PERMIT

SEWAGE DISPOSAL SYSTEM

SUBDIVISION _____ LOT 5 _____ ROAD 3700 Woodbine Road

REPAIR - PURPOSE - TO EVALUATE EXISTING DRYWELL TO SUPPORT 3 BEDROOM EXPANSION - 2 BEDROOM DELETION (1 BEDROOM NET ADDITION) BUILDING PERMIT NUMBER: B00115069.

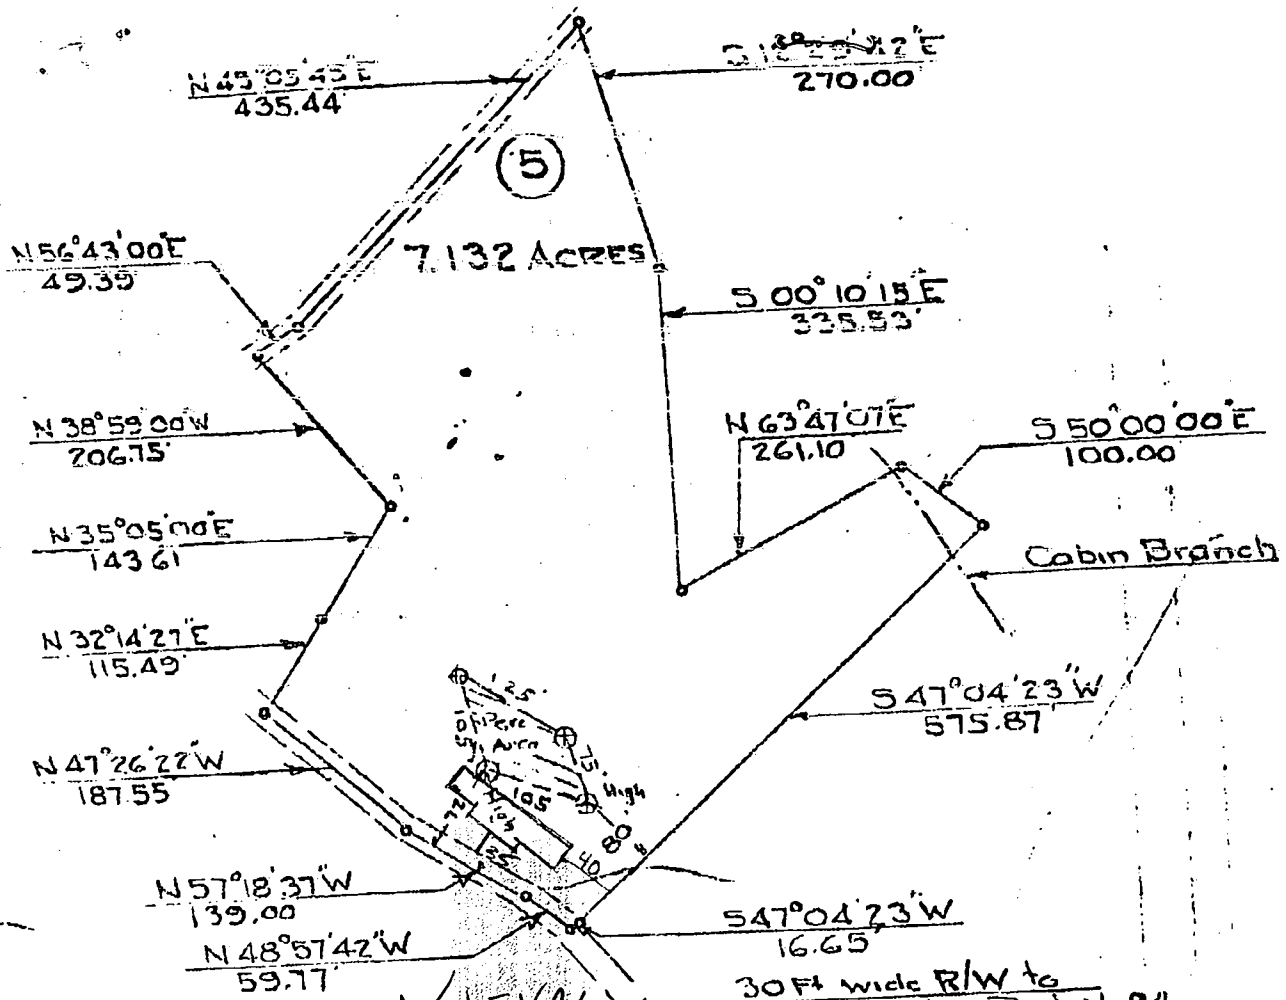
REMARKS: 12/2/98 EVAL OF EX. D/W FOR ADDITION REVIEW; EX. D/W BOT
12' DEEP. BELOW GRADE; 3 1/2' H₂O DEPTH INV @ 4 1/2' - 5' BELOW GRADE
DEPTH OF D/W 8 1/2', D/W IS < 50% FULL; OK TO SIGN BP FOR
3BR ADD'N (w/2 BR DELETION), 1BR NET GAIN (MR)
NO WORK DONE

00015069
 OK FOR ADD'N
 (MR) 12/2/98
 D/W EVAL
 SEE SEPTIC
 REPAIR
 RECORDS

Approved Septic System Plan
 Howard County Health Department
 BP 00102020

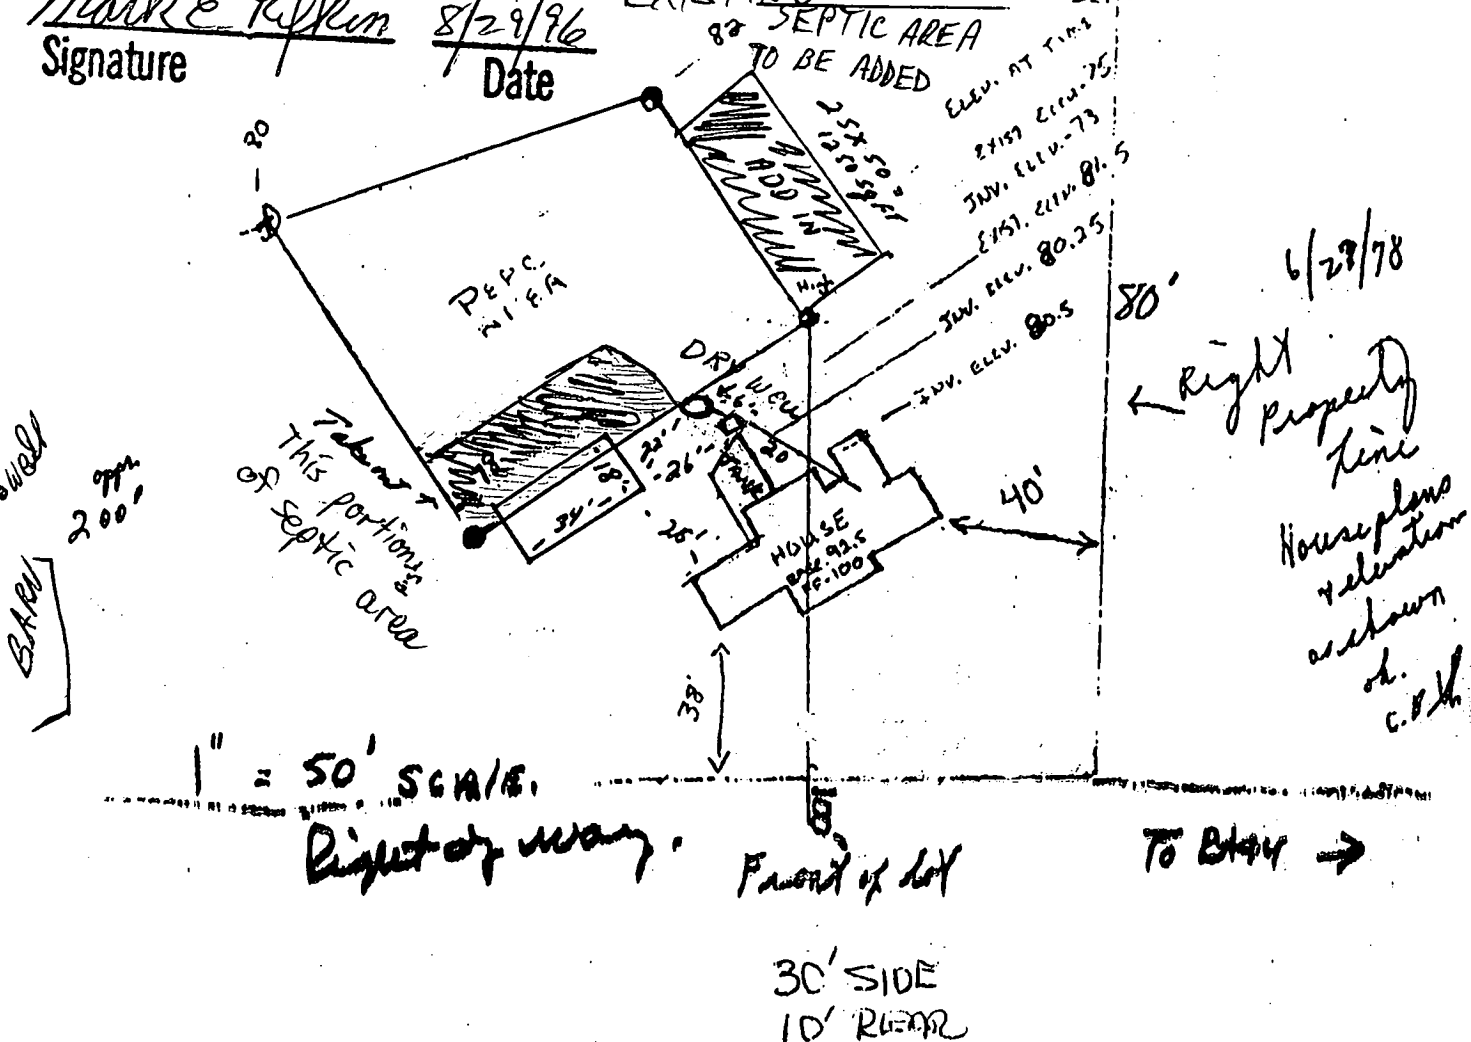
Pool 18 x 36
 25' From House
 26' From Tank
 22' From Driveway
 200' to well
 200' Left Side
 400' Rear
 100' Right Side
 100' Front

BY COPY OF THIS PLAN
 THE HEALTH DEPT.
 ACCEPTS THIS
 MODIFICATION TO THE
 EXISTING SEPTIC AREA
